**Class 2 Permit Modification Request**

**Removal of Deteriorating/Non-Essential Water Level Monitoring Program Wells**

**Waste Isolation Pilot Plant  
Carlsbad, New Mexico**

**WIPP Permit Number - NM4890139088-TSDF**

Figure 1. Proposed Changes to Wells in Permit Figure L-14, *Groundwater Level Surveillance Wells*

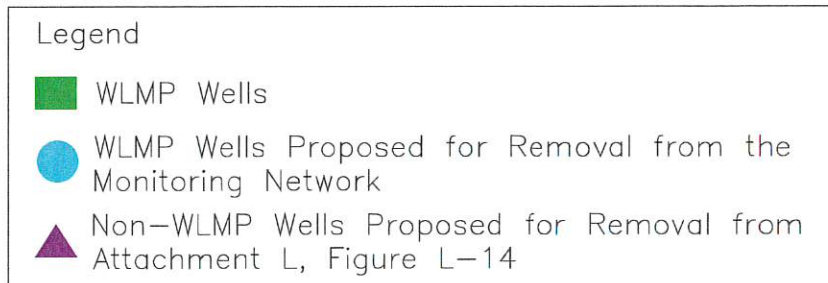
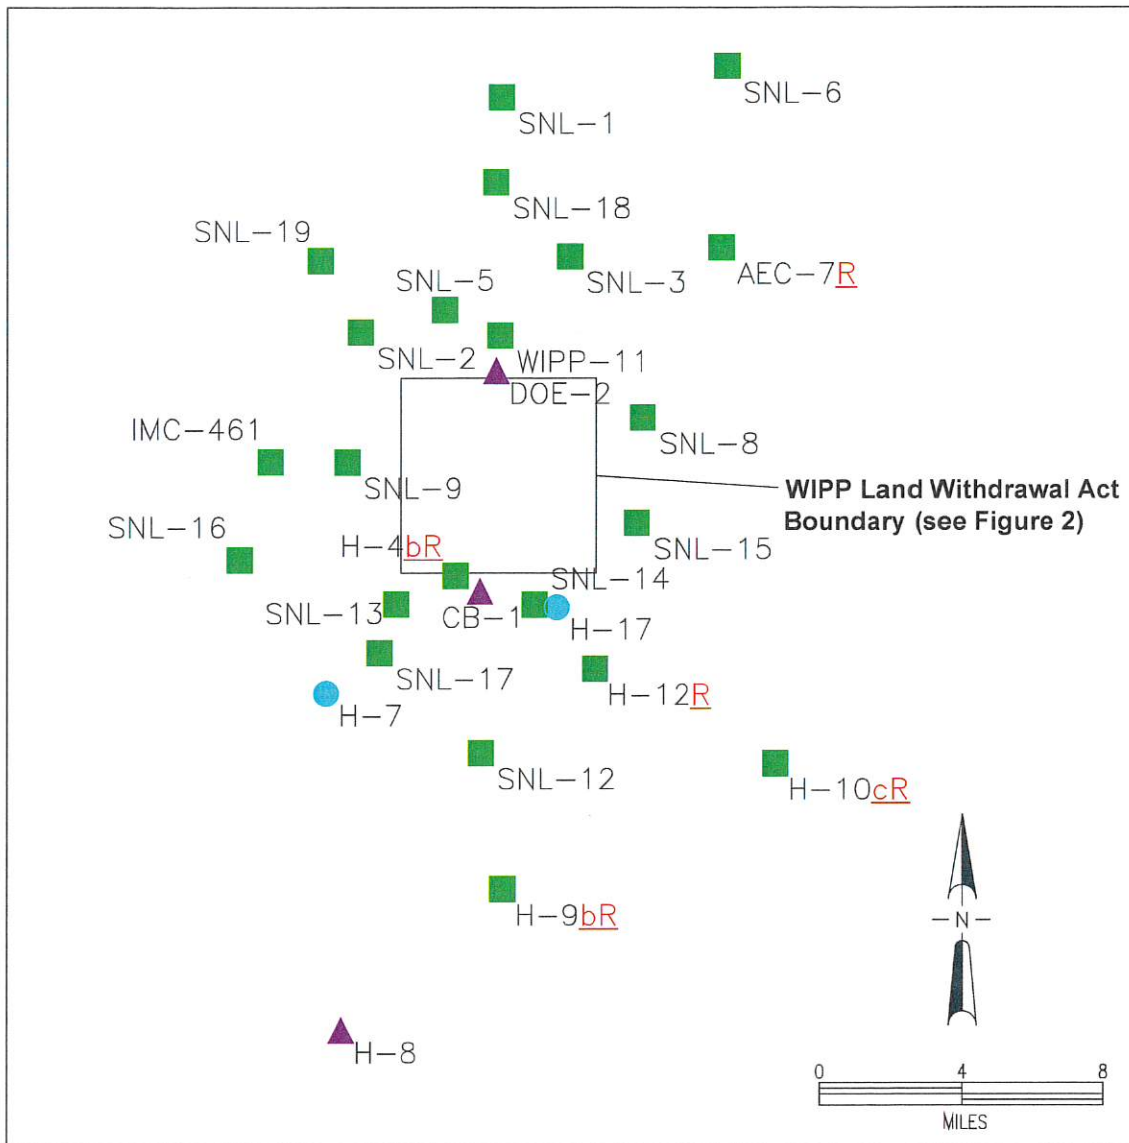
- Permit Attachment L, Figure L-14, *Groundwater Level Surveillance Wells*
  - Remove wells H-18, WIPP-18, H-14, DOE-2, CB-1, and H-8 (as shown in Figures 1 and 2).

- Modify the Exclusive Use Area boundary.
  - Delete “ASER 3-11-09” from the bottom right corner of the figure.
  - Change the well identification numbers (as shown in Figures 1 and 2) in the figure as follows:

- Change “AEC-7” to “AEC-7R”
    - Change “H-4” to “H-4bR”
    - Change “H-5” to “H-5b”
    - Change “H-6” to “H-6bR”
    - Change “H-9” to “H-9bR”
    - Change “H-10” to “H-10cR”

- Change “H-11b4” to “H-11b4R”
    - Change “H-12” to “H-12R”
    - Change “H-15” to “H-15R”
    - Change “H-19” to “H-19 pad”

- Permit Attachment L, Figure L-14, *Groundwater Level Surveillance Wells*
  - Wells H-18, WIPP-18, H-14, DOE-2, CB-1, and H-8 need to be removed from this figure because they monitor the Bell Canyon Formation and the Magenta Dolomite Member of the Rustler Formation; the WLMP only consists of wells monitoring the Culebra, and as a result, wells H-18, WIPP-18, H-14, DOE-2, CB-1, and H-8 are not listed in Permit Attachment L, Table L-4. These wells had been included in the figure because they were part of the Annual Site Environmental Report in 2009. These wells need to be removed to provide an update to this figure and to assure accuracy and consistency with Table L-4.

**Figure L-2**  
**WIPP Facility Boundaries Showing 16-square-Mile Land Withdrawal Boundary**

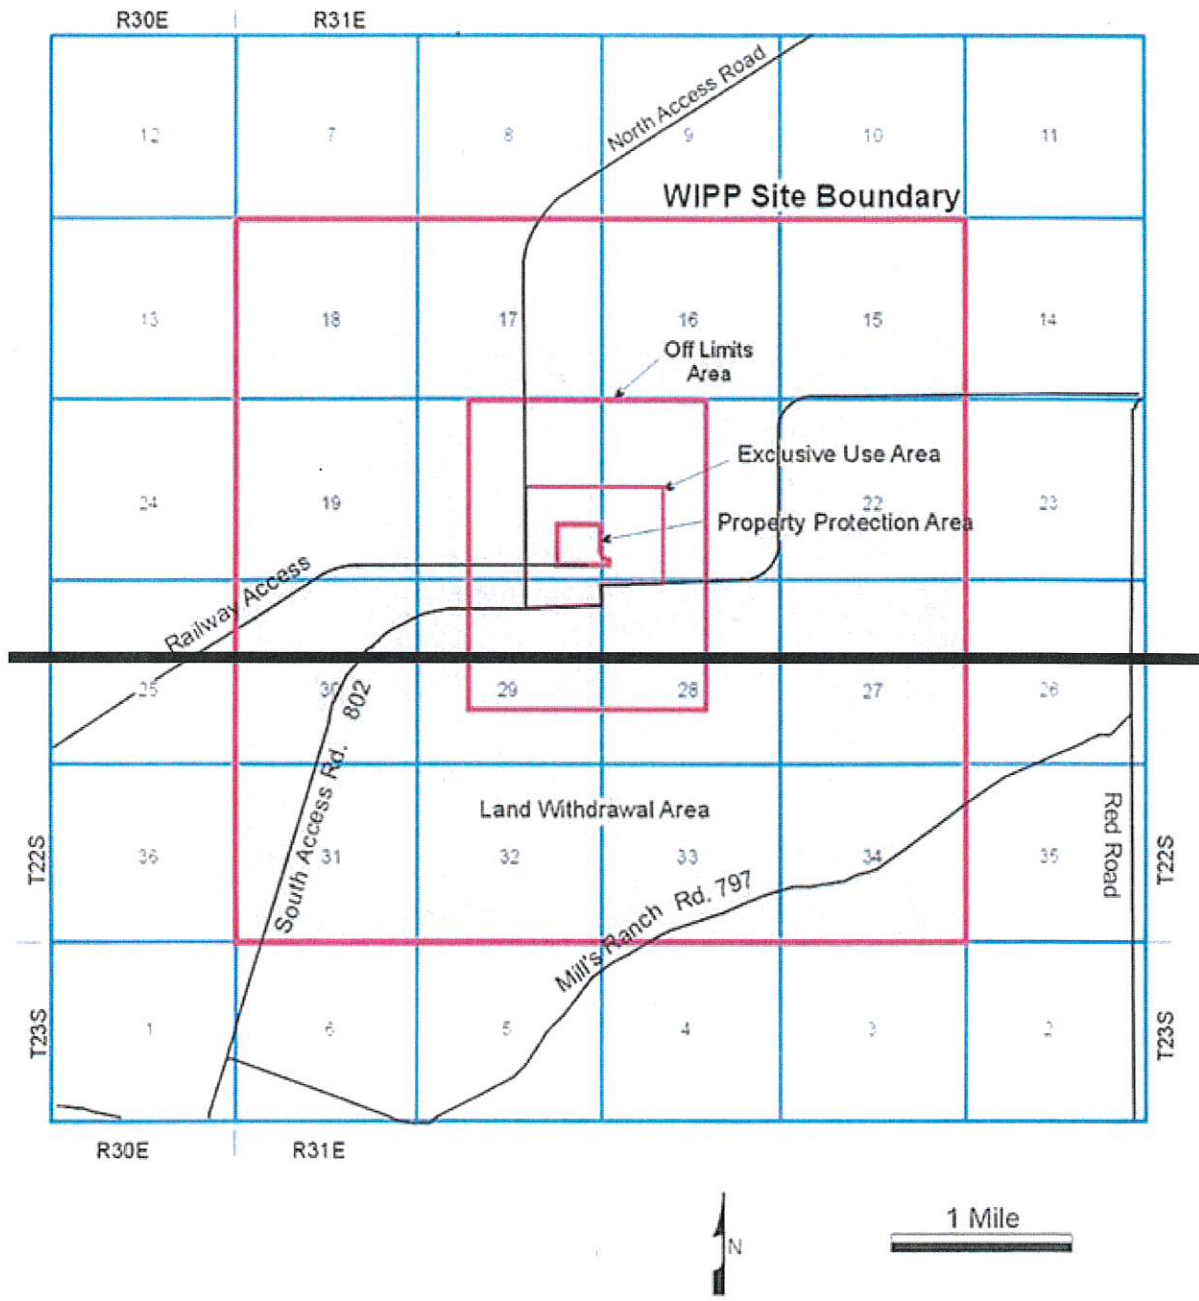
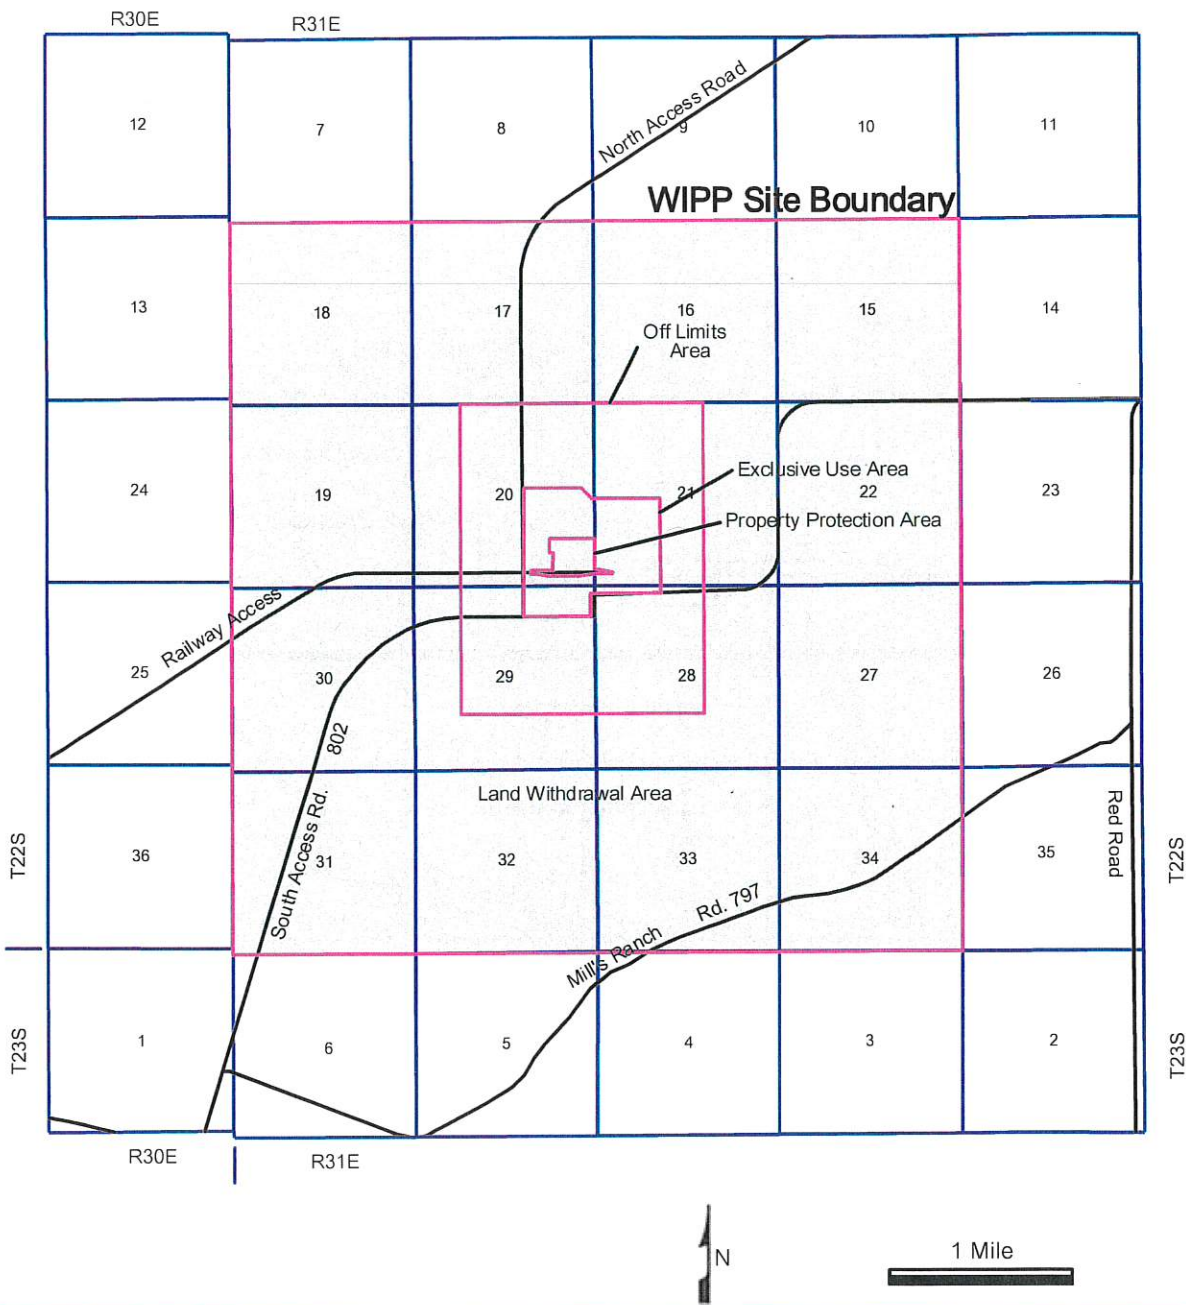
- Change “SNL-03” to “SNL-3”
  - Change “SNL-05” to “SNL-5”
  - Change “SNL-06” to “SNL-6”
  - Change “SNL-08” to “SNL-8”
  - Change “SNL-09” to “SNL-9”
- Permit Attachment L, Figure L-2, *WIPP Facility Boundaries Showing 16-square-Mile Land Withdrawal Boundary* – Modify the Exclusive Use Area and Property Protection Area boundaries and add section labels for sections “20” and “21.”

- Permit Attachment L, Figure L-2, *WIPP Facility Boundaries Showing 16-square-Mile Land Withdrawal Boundary* – The Exclusive Use Area and Property Protection Area require modification to more accurately depict the boundaries and ensure consistency with the Property Protection Area boundary in Figures L-6 and L-14. In addition, missing section labels need to be added for sections “20” and “21” for completeness.

Figure L-5  
 Culebra-Freshwater-Head Potentiometric Surface

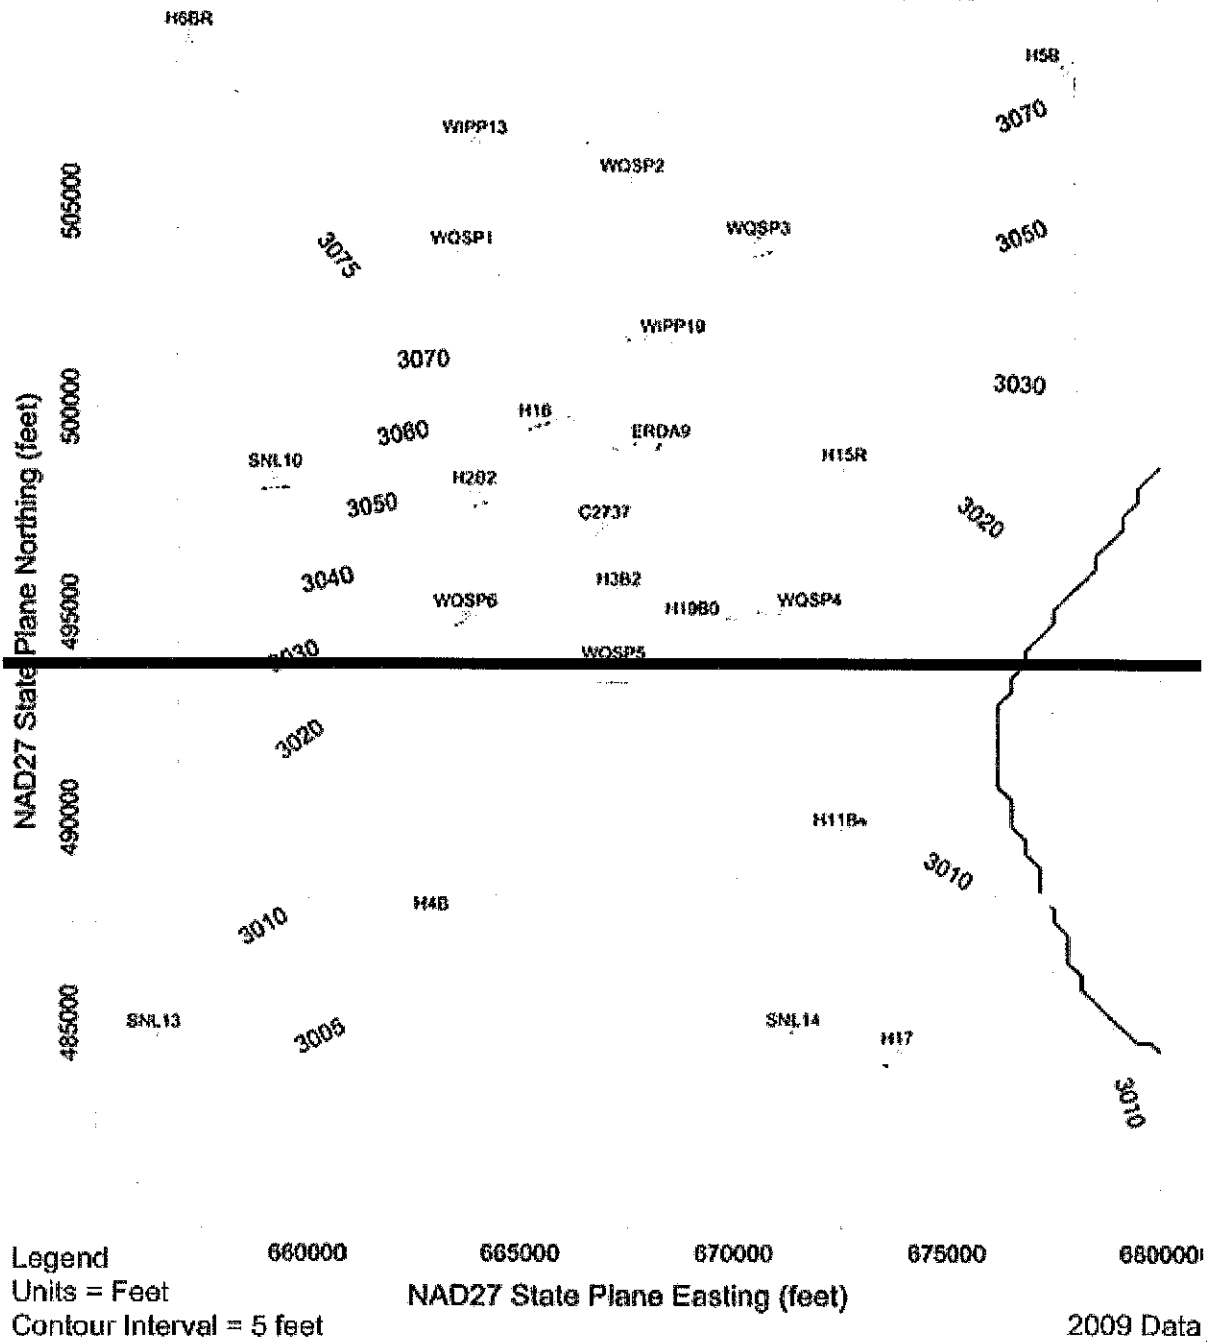
- Permit Attachment L, Figure L-5, *Culebra Freshwater-Head Potentiometric Surface* – Delete this figure.
- Permit Attachment L, Figure L-6, *Detection Monitoring Well Locations* – Modify the Exclusive Use Area boundary and the figure labels for “WIPP Site,” “Exclusive Use Area,” “Property Protection Area” and “Off Limits Area.”

- Permit Attachment L, Figure L-5, *Culebra Freshwater-Head Potentiometric Surface* – This figure is proposed for removal from the Permit since this figure is obsolete and is updated in the Annual Culebra Groundwater Report, which is provided to the NMED in accordance with Permit Part 5, Section 5.10.2.1, *Data Evaluation Results*.

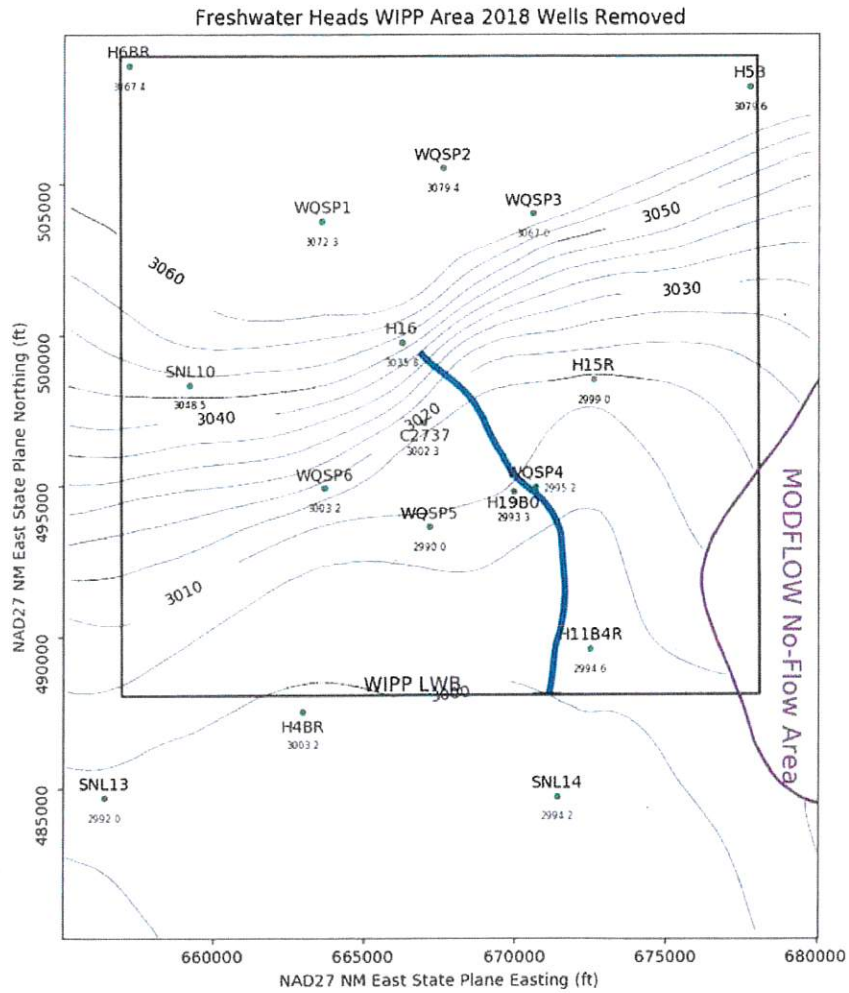
Per your request (email attached), the contour map presented below in Figure 1 was created utilizing data from the 2018 Culebra potentiometric surface map reported in the *Analysis Report for Preparation of the 2018 Culebra Potentiometric Surface Contour Map* (Hayes, 2019), but with seven wells, ERDA-9, H-2b2, H-3b2, H-7b1, H-17, WIPP-13, and WIPP-19, removed from the analysis. This analysis is consistent with the Kuhlman, 2010 *Analysis Report AP-111* that discussed the Culebra water level monitoring network design and the minimal impact of removing these seven wells that were proposed for plugging and abandonment.

The blue line in Figure 1 corresponds to the calculated path a water particle would take through the Culebra from the coordinates corresponding to the WIPP waste handling shaft to the Land Withdrawal Boundary. The particle track has a path length of 13355 ft (4070 m). The calculated travel time of the particle is 6019 years with an average speed of 2.2 ft/year (0.68 m/year). The original particle track length presented in Figure 2 had a path length of 13355 ft (4070 m) a calculated travel time of 5979 years and an average speed of 2.2 ft/year (0.68 m/year).
